RE: 447 Warburton Ave

Please see attached revised drawings for the above reference address. The changes include the following:

PROPOSED ALTERATION/ ADDITION

AT: 447 WARBURTON AVE. HASTINGS-ON-HUDSON, NY

Dwg. Name:
**SURROUNDING
PROPERTIES**

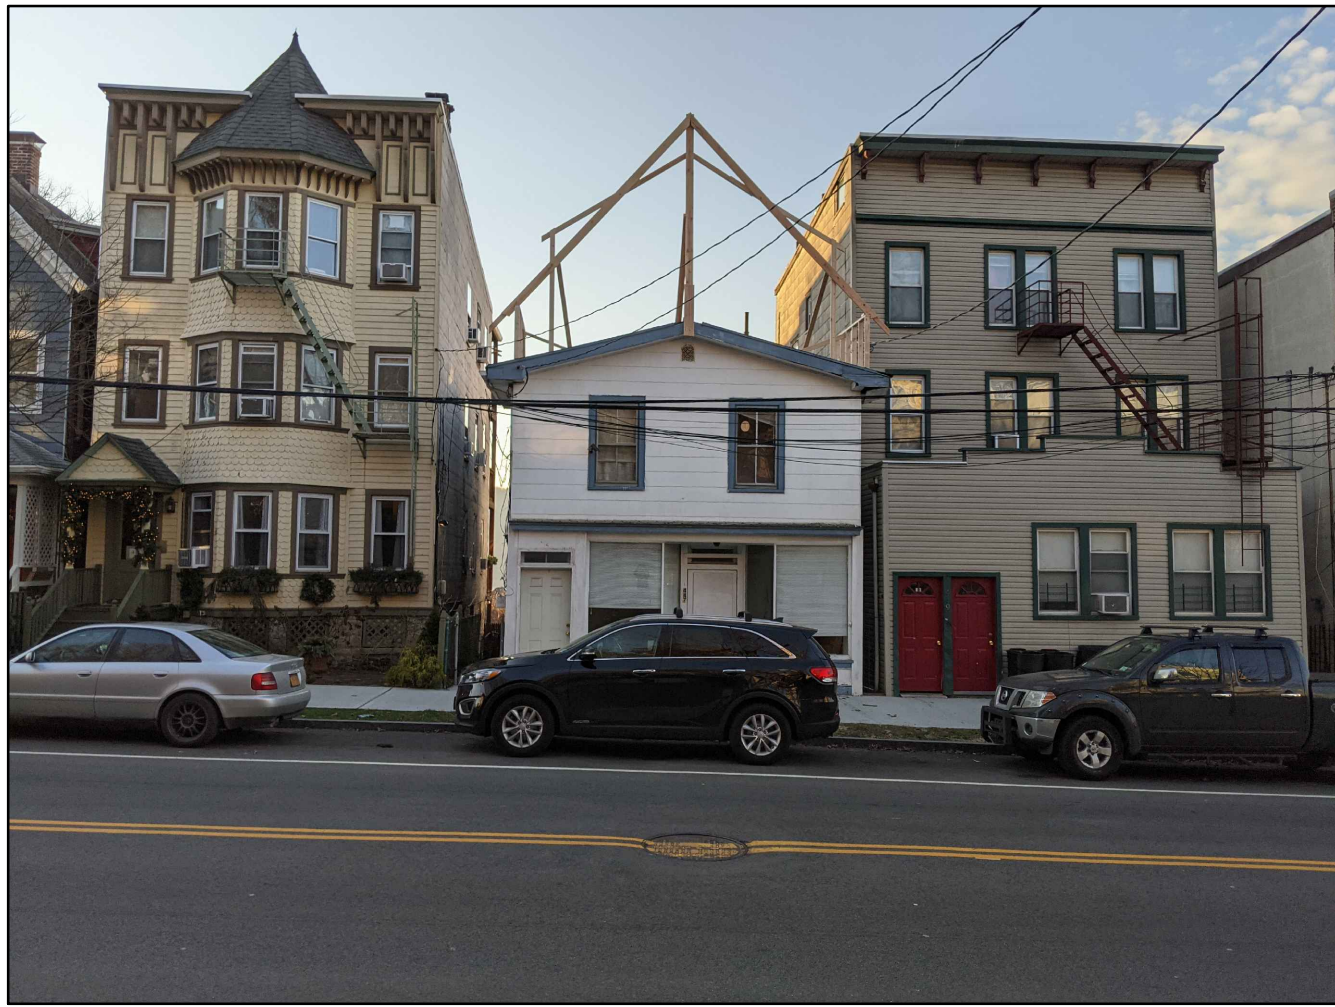
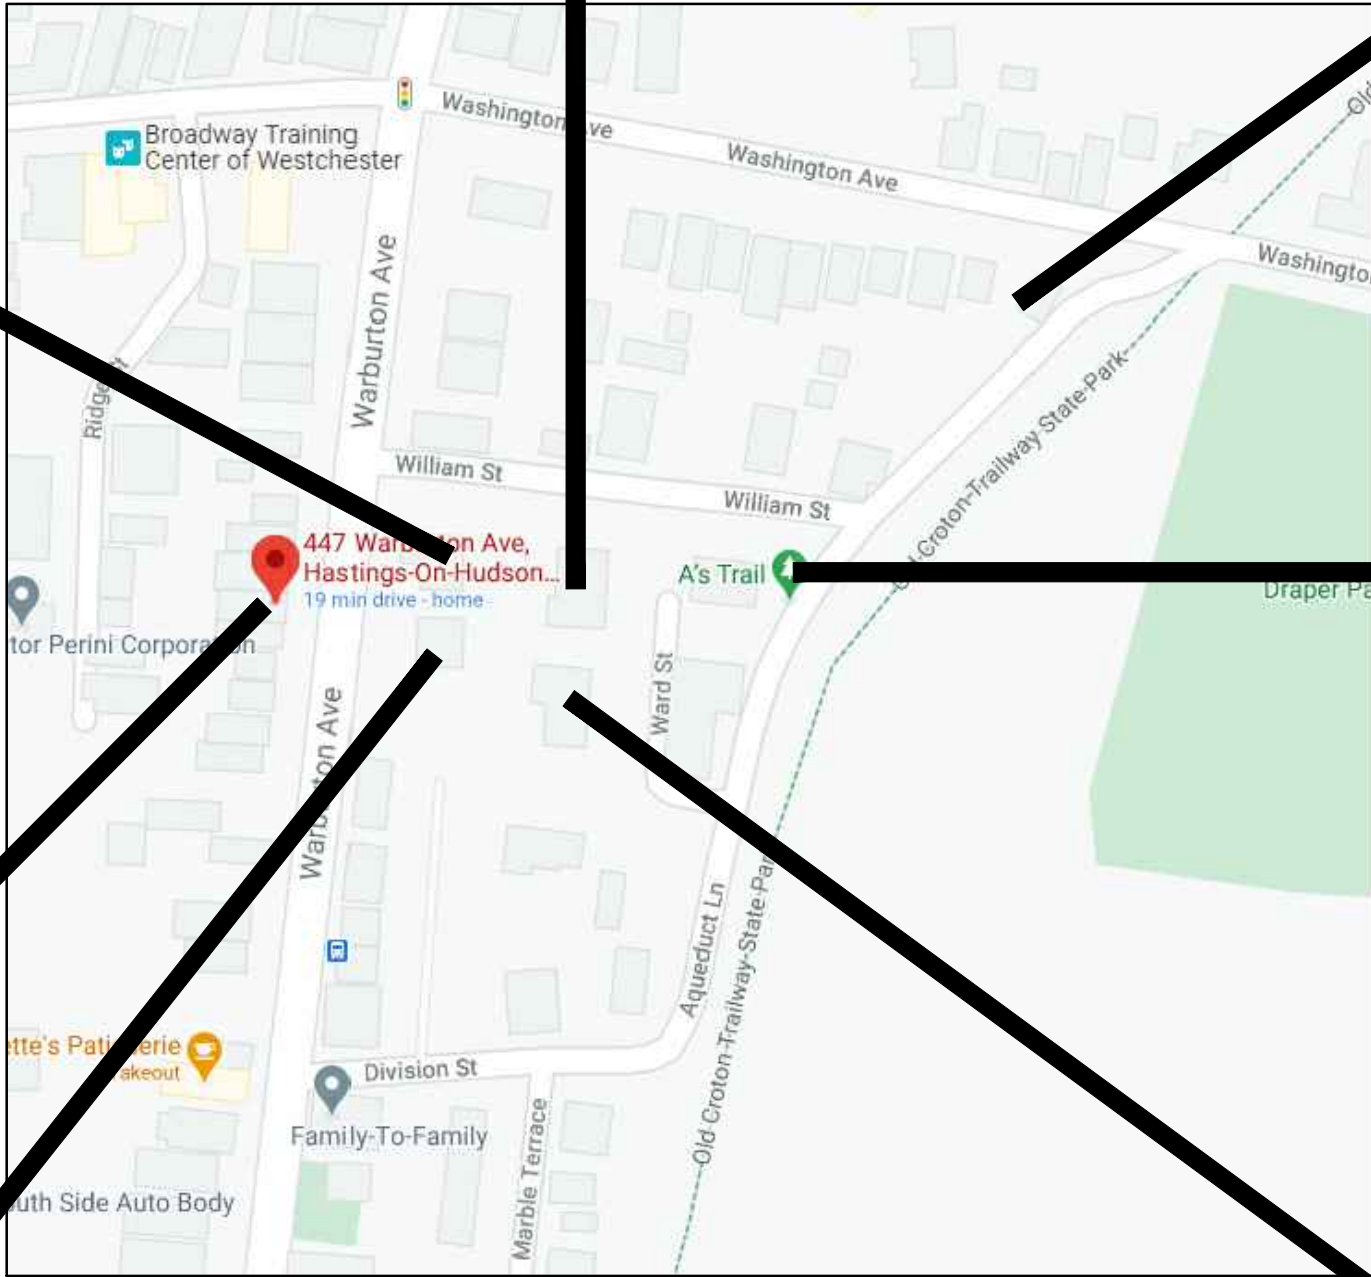
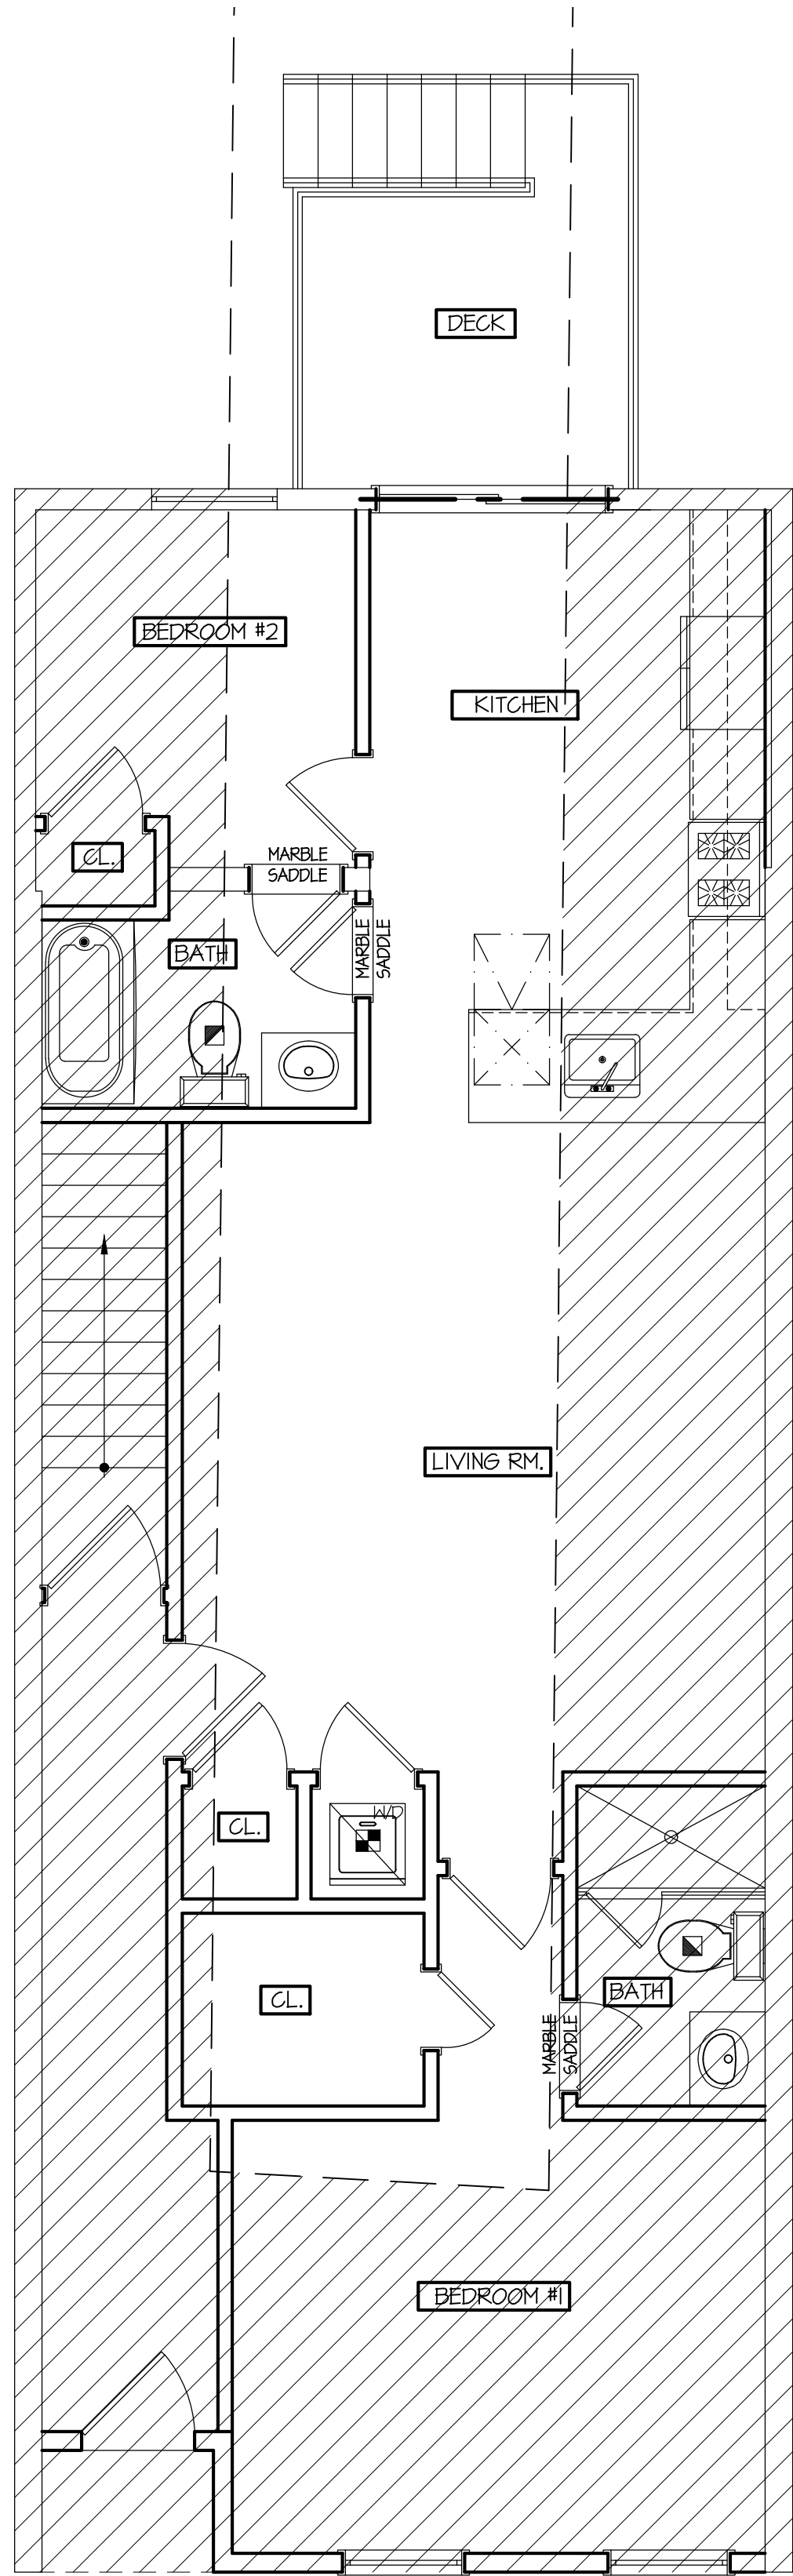
- 1.) The zoning chart has been revised because the deck now complies with the setback
- 2.) We have changed the size of the sliding doors at the rear of the dwelling on the first, second and third floor.
- 3.) The second-floor deck has been reduced and screen walls have been added.
- 4.) The third-floor front wall 4' back from the front setback.
- 5.) Third-floor knee wall has been reduced from 3'-0" to 1'-6"
- 6.) All elevations have been revised
- 7.) Dimensions have been added to ZA-5 sheet.
- 8.) Renderings have been revised and additional angles have been provided.
- 9.) Renderings from neighbor's residence have been added.
